Gegenstand: Bremsklappen, unteres Blatt

Betroffen: Segelflugzeug LS4 und LS4-a, alle Werknummern bis 4340

LTA 83-158

Subject: Air brakes, lower blade
Effectivity: Sailplane models LS4 and LS4-a, all serial numbers up to 4340
Accomplishment: Prior to next flight
Reason: Possible jamming of lower air brake blade at high speeds

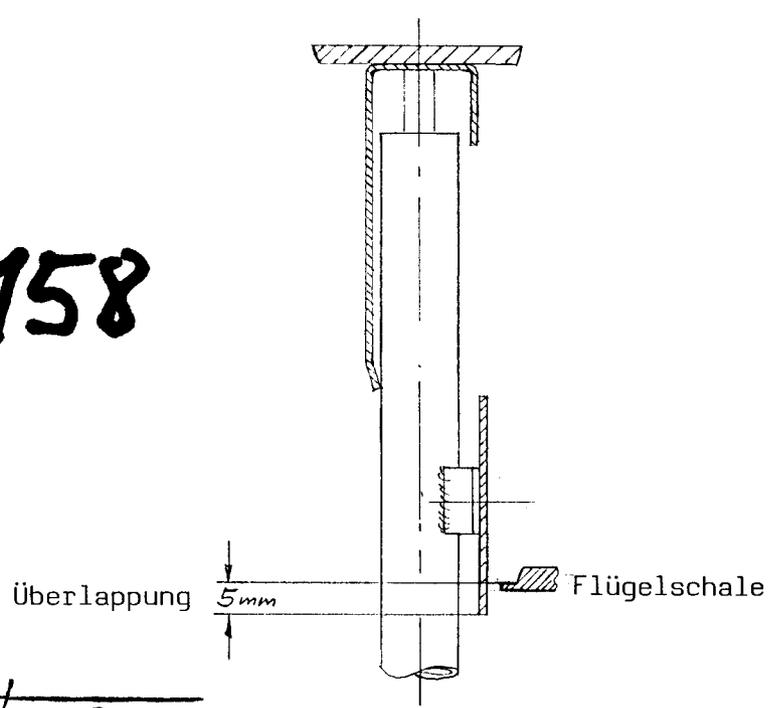
Vorgang: Mögliches Verkleben des unteren Bremsklappenblatts bei hohen Geschwindigkeiten

- 1) Segelflugzeug aufrüsten
- 2) Bei voll ausgefahrenen Bremsklappen Messung der Überlappung zwischen BK-Blatt und Schale mittig zwischen beiden Hebeln. Unter 5 mm Überlappung ist entsprechend Punkt 3 zu verfahren
- 3)a. Bremsklappen so weit einfahren, daß die Überlappung an beiden Flügeln mindestens 5 mm beträgt
- b. Kontrolle der Ausfahrhöhe am inneren Hebel- Mindestwert 150 mm. Bei Unterschreiten - Rücksprache mit dem Hersteller
- c. Anschlag an der BK-Stoßstange im Cockpit unter 45° von schräg unten so ansetzen, daß bei Anlegen an den Hauptspant Bedingung a. erfüllt wird.

- Instructions:
- 1) Assemble sailplane
 - 2) With air brakes fully extended, measure overlap between lower blade and wing shell central to levers. When overlap is below 5 mm (0.2 in) proceed according to step 3.
 - 3)a. Retract air brakes until overlap is at least 5 mm (0.2 in) at both wings
 - b. Check extending height at inner lever, minimum is 150 mm (5.91 in). If below minimum, contact manufacturer.
 - c. Rivet stop to air brake pushrod in cockpit from approx. 45° below horizontal such, that main bulkhead reduces travel to yield required overlap

Material: Anschlag 4R6-15, Stahl-Blindniet 4x10 (Bohrdurchmesser 4.1 mm)

Material: Stop 4R6-15, Steel blind rivet 4x10, (drill dia.4.1 mm, DN 20)
Weight and Balance: Not affected
